Explanation of Significant Differences

AT&SF Albuquerque Superfund Site Albuquerque, New Mexico

**United States Environmental
Protection Agency
Region 6
Superfund Division**

February 2010

Figure 2
Site Excavation Areas

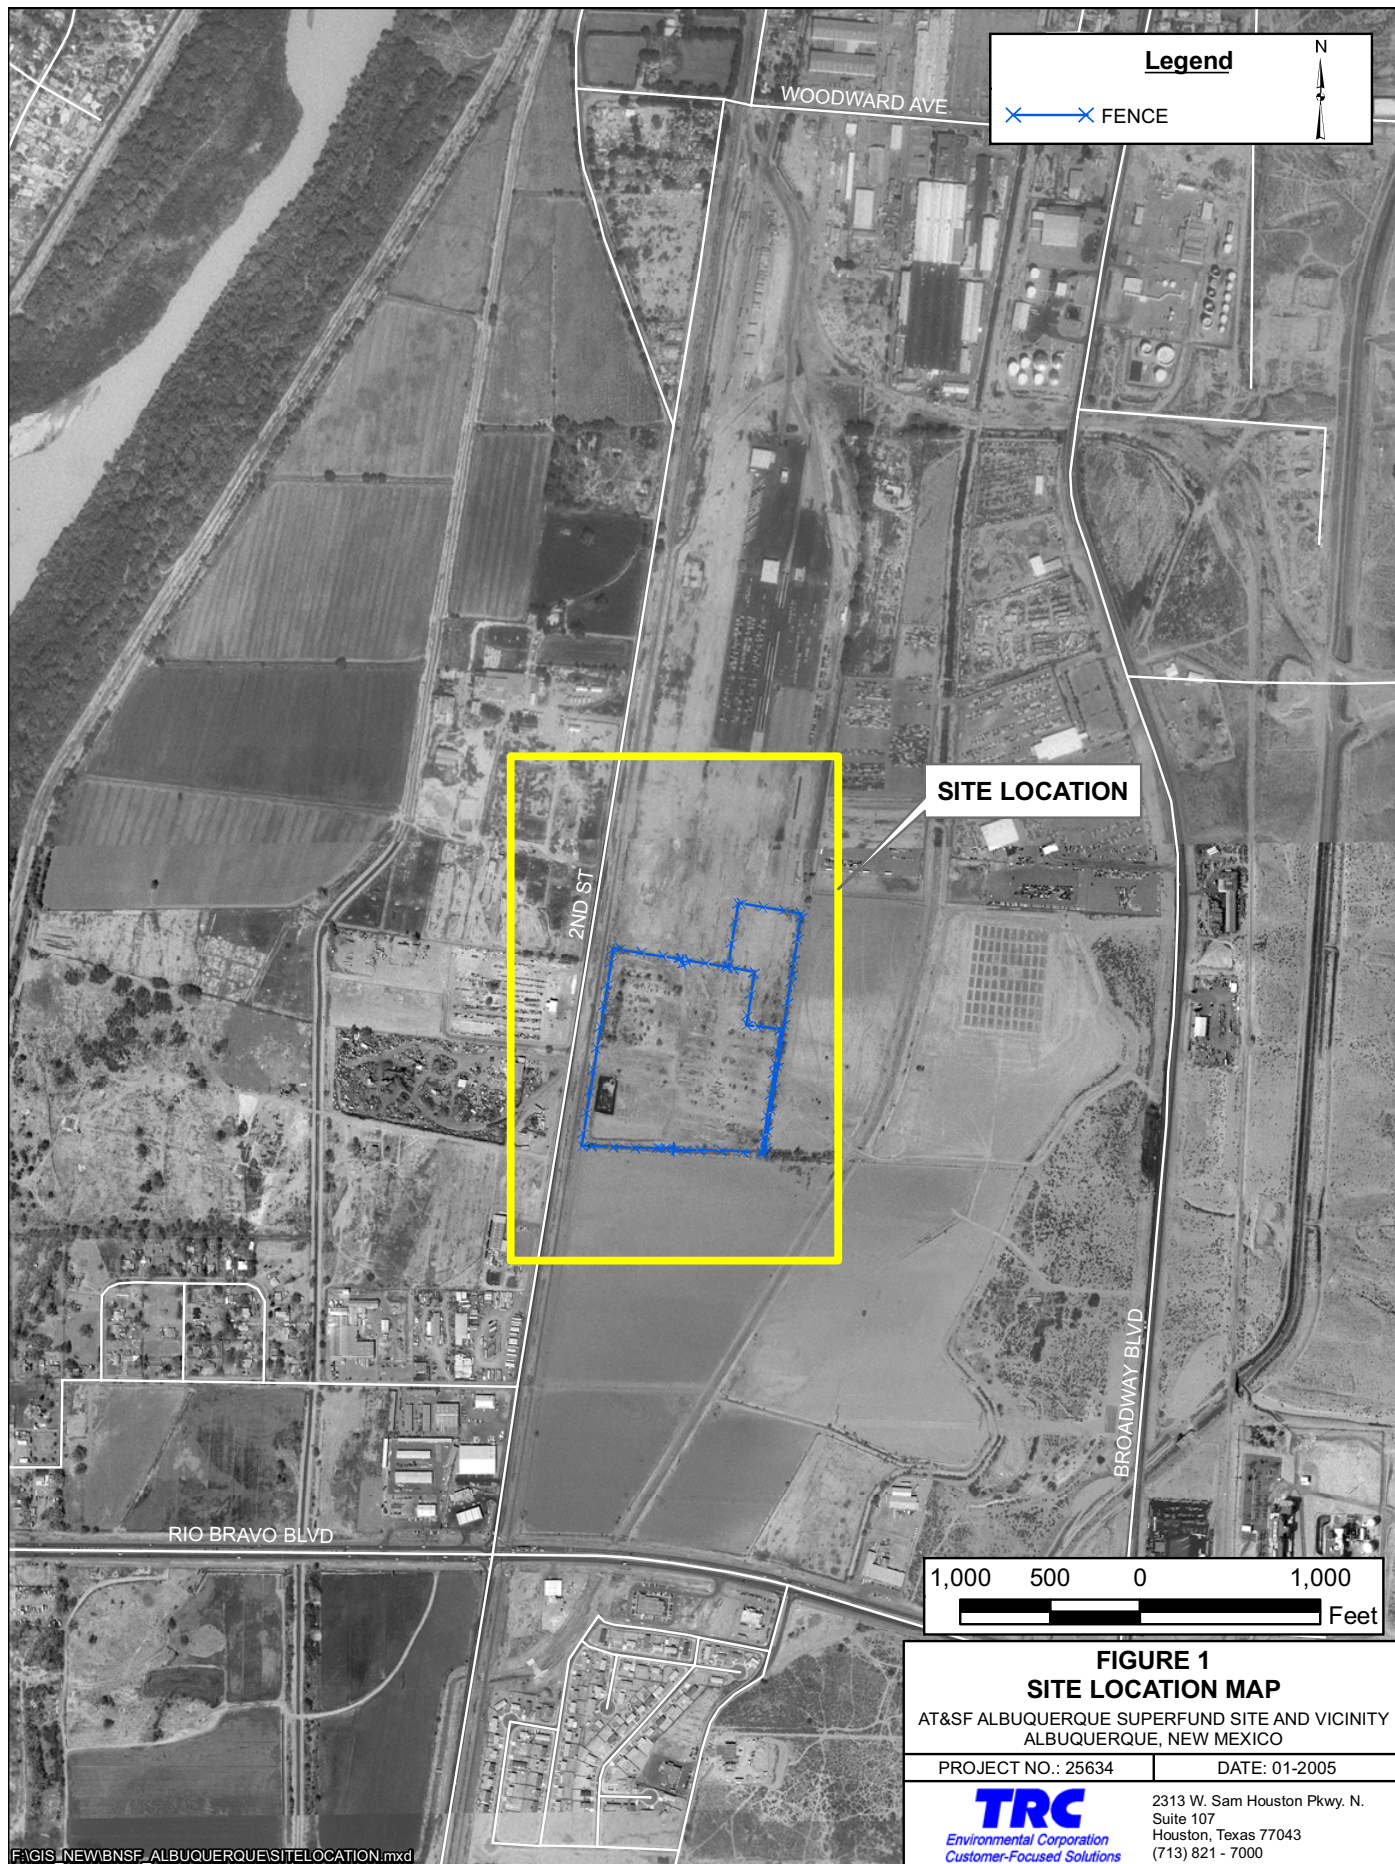
During implementation of the soil remedy, soil exceeding the ecological soil remediation goal (SRG) of 200 milligrams per kilogram (mg/kg) for zinc has been found on the Site in areas not previously identified during the Site remedial investigation (Figure 2). The increased areal extent of the zinc-contaminated soil has led to a greater than 50% increase in the volume of soil that requires excavation, treatment, and capping due to exceedances of the 200 mg/kg SRG for zinc. (The final volume will be documented in the remedial action report.) The ROD specifies that soil exceeding the SRG would be excavated down to a maximum depth of 3 feet (ft) in order to be protective. In order to keep excavated soil volumes at a manageable level for in-situ treatment and capping, the EPA has decided, at the recommendation of BNSF and with the concurrence of the NMED, to reduce the depth of excavation to a maximum of 2 ft for soil that only exceeds the SRG for zinc (Appendices A and B).

In summary, soil excavation to a maximum depth of 2 ft will be conducted in areas where the only SRG exceeded is zinc, while areas where the BAP equivalent SRG is exceeded, either solely or in addition to the zinc SRG, will be excavated to a maximum depth of 3 ft in order to be protective of human health.
